## SERVICE BULLETIN: JSB 012-9

Issue: 9

Date: 30<sup>th</sup> November 2022

Subject: Jabiru Engine Flywheel Attachment

Figure 2 - Plain washers compared to Nordloc washers (flywheel with steel centre).

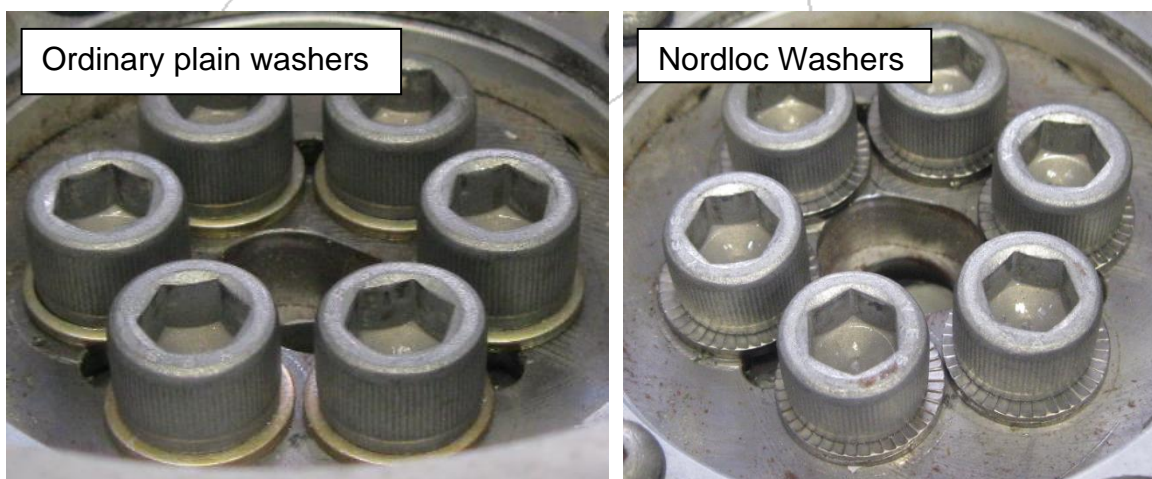
This service bulletin also acts to inform maintainers and operators of a design change to the flywheel connection which **must** be implemented on existing engines whenever flywheel bolts are replaced (i.e. at the intervals specified in JEM0002 or at overhaul).

Flywheel screws must now be installed using Nordloc washers (replacing the previous installation which used either plain or Belleville washers). Jabiru engines of any and all flywheel configurations (as defined in Table 1) should now use Nordloc washers. These washers are easily identified via visual inspection as shown below in Figure 2.

When Nordloc washers are used on an aluminium surface a steel plate must be used to protect the aluminium surface. These are available from Jabiru.

Figure 3: Flywheel with Aluminium centre and steel wear plate.

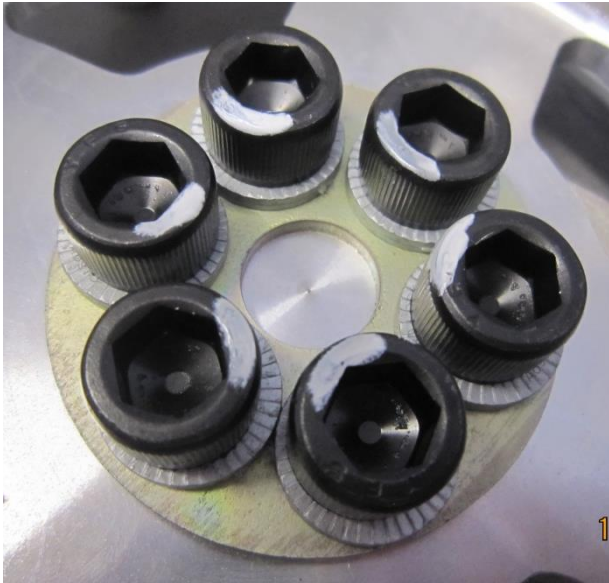
- vii) Install the Steel wear plate. Note: if you have a flywheel with a steel centre “Starfish” a steel wear plate is not required.
- viii) Install new Cap screws with Nordloc washers and torque up as described in the Overhaul manual JEM0001 (check for latest issue). Note that only new “Unbrako” or “Brighton Best 1960-Series” screws are to be used.
